# Rio Algom

Re: **Discharge Plan - 169**  
**Response to NMED February 1, 2001 Letter**

Discharge Permit – DP-169

Response to  
NMED Comments

**Figure 1**  
**Quivira Facility – DP-169**

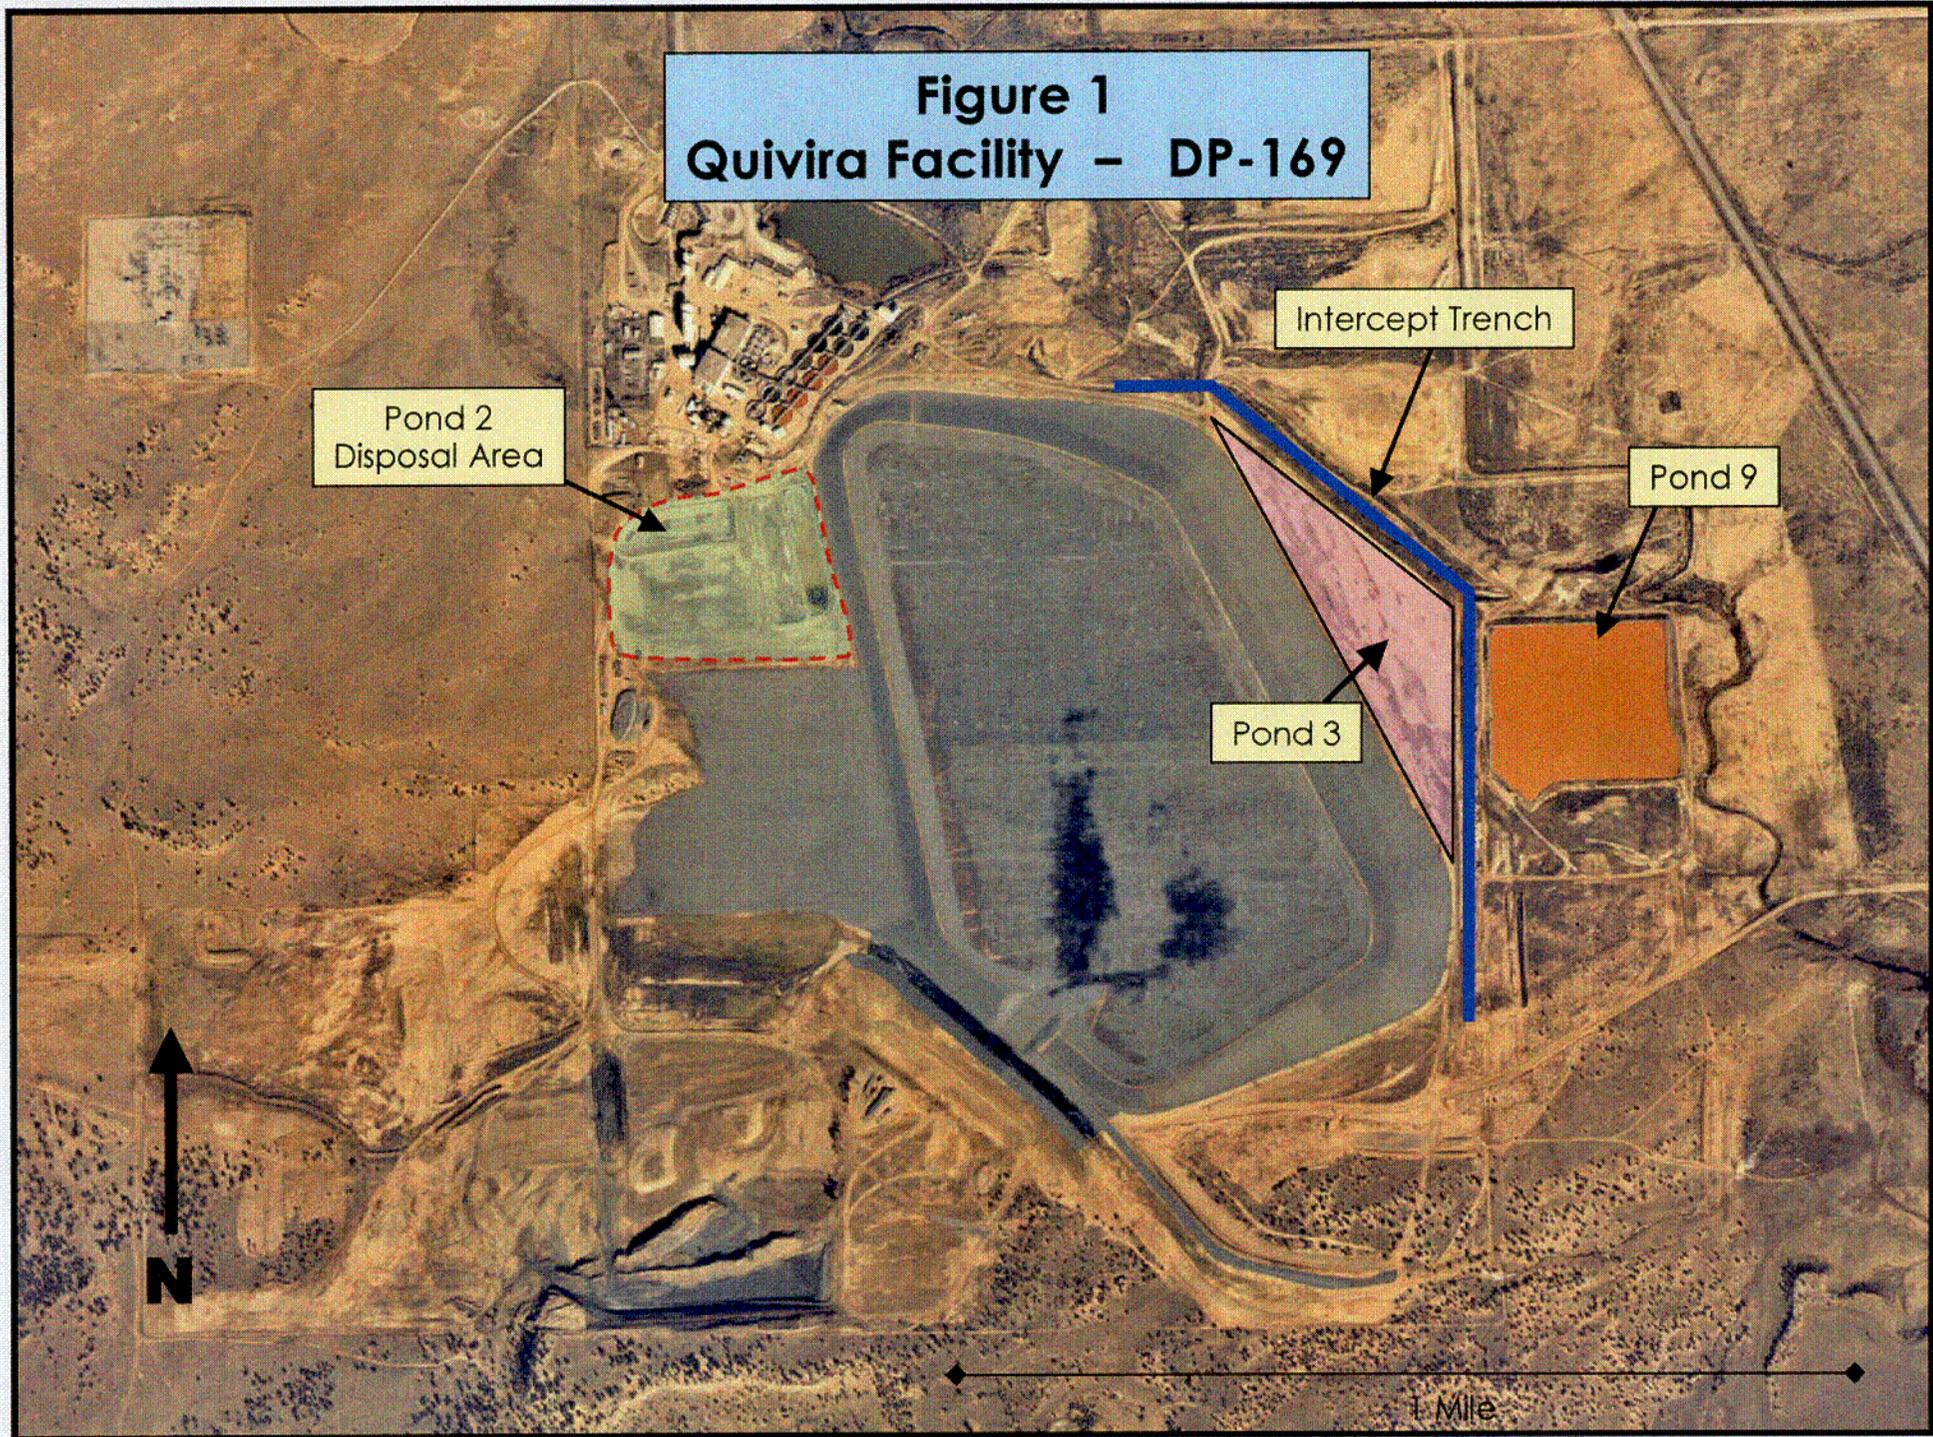
The closure plan for Pond 9 should consider the alternative of moving sediments to immediately west of tailings ponds, rather than disposal of sediments in the interceptor trench and directly in contact with the alluvial aquifer.

Please submit a schedule with proposed dates for implementation of the closure plan for Pond 9, interceptor trench and the shallow ground water remediation system.

Pond 9 is currently utilized for collection and evaporation of various 11e.(2) byproduct waste streams generated at the mill including the collection of alluvial groundwater associated with the corrective action program implemented at the site. The purpose of the groundwater cleanup plan for the alluvium is to flush the alluvium in order to collect the byproduct material that has seeped from the impoundment. Figure 1 depicts Pond 9, the interceptor trench, and Pond 2.

Placement of Pond 9 sediments into the trench should not result in having the materials in contact with any water as the disposal location is expected to be in a dry environment due to elimination of the recharge source and draining and drying out of the alluvium. Quivira plans on placing the material into the trench in 3 to 5 foot layers with stabilization/compaction performed to minimize voids within each layer. Following placement and stabilization of the pond sediments, a compacted layer of low permeability material will be placed to minimize infiltration of precipitation moisture. Closure of former evaporation pond #3, located immediately west of the trench, will result in the majority of the trench area being included within the footprint of the final outslope of pond 3.

Under Quivira's proposed plan, pond 9 will be closed by disposing of the dried sediments into the intercept trench, beginning from the southern end of the trench. The remaining capacity of the trench will be backfilled with an appropriate radon barrier and additional soil for revegetation efforts. The former Pond 9 area will also be revegetated. The monitoring wells associated with the discharge permit will be plugged with grout to just below the final surface grade and the hole will be backfilled with native soils and revegetated. The fresh water recharge channel may either be backfilled or realigned for use as a diversion channel.
